UNITED STATES PATENT AND TRADEMARK OFFICE

APPLICATION NO.	FILING DATE	FIRST NAMED INVENTOR	ATTORNEY DOCKET NO.	CONFIRMATION NO.
09/993,996	11/14/2001	Bernd Halbrock	65857-0037	8824

Office Action Summary

DETAILED ACTION

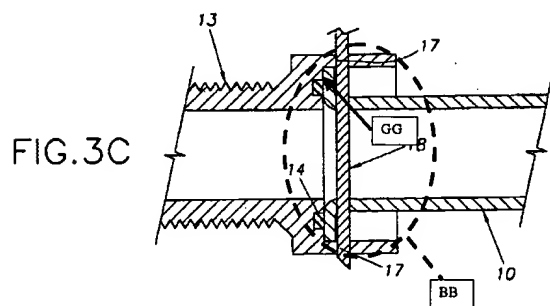
In regards to claim 1, Lewis discloses a quick-connect device for connecting fluid lines comprising a first connecting element (13) that includes an annular planar first support surface (16), an inclined surface, and an annular receptacle space (BB in Figure 3C below) with a first sealing surface and a second sealing surface (inside of the groove holding seal 14), an annular sealing element (14) that is arranged in the receptacle space and adapted (capable) to contact the first and second sealing surfaces, a second connecting element (10) that includes an annular flange that has a third sealing surface (SS) and an annular second planar support surface (12) adapted (capable) to contact the first annular support surface, and a clamping device (18), wherein the third sealing surface is adapted to contact the annular sealing element.

In regards to claim 26, Lewis discloses a support device (GG see Figure 3C above).
